ON-SITE SEWAGE DISPOSAL SYSTEM HOWARD COUNTY HEALTH DEPARTMENT BUREAU OF ENVIRONMENTAL HEALTH

03-330893

SUBDIVISION: Brantwood 2/1 LOT NUMBER: 28

ADDRESS: 3008 Seneca Chief Trail PROPERTY OWNER: NV Homes

P516011-B

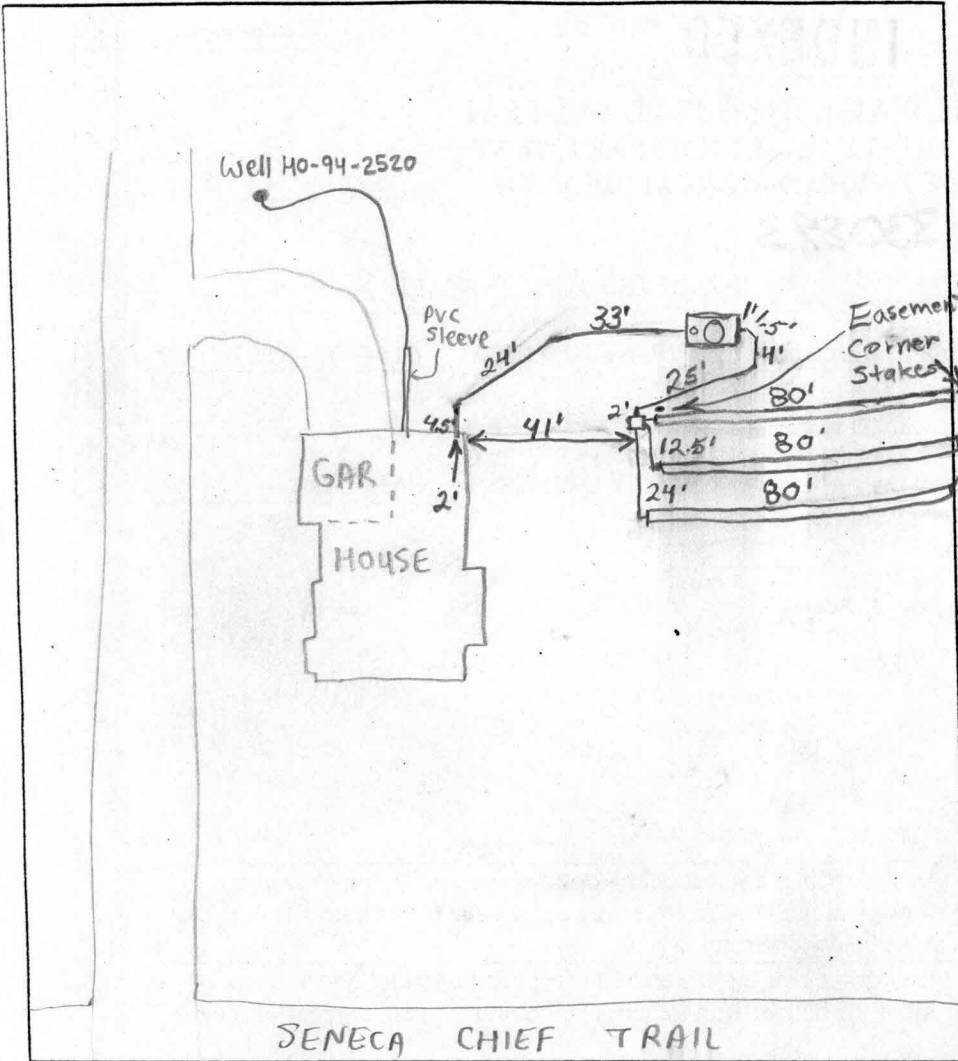
PRE-CONSTRUCTION INSPECTION: 9/11/01 To install as per B.P. Tank
relocated because of neighboring well. (BB)
 INSPECTION COMMENTS: 9/12/01 First trench done. Second trench
started. Need house connection. (BB) 9/13/01 Need house
connection. O.K. to cover. (BB) 10/5/01- HOUSE CONN. VERIFIED TO HAVE
BEEN MADE THRU T/C W/ BUILDER. (SRK)
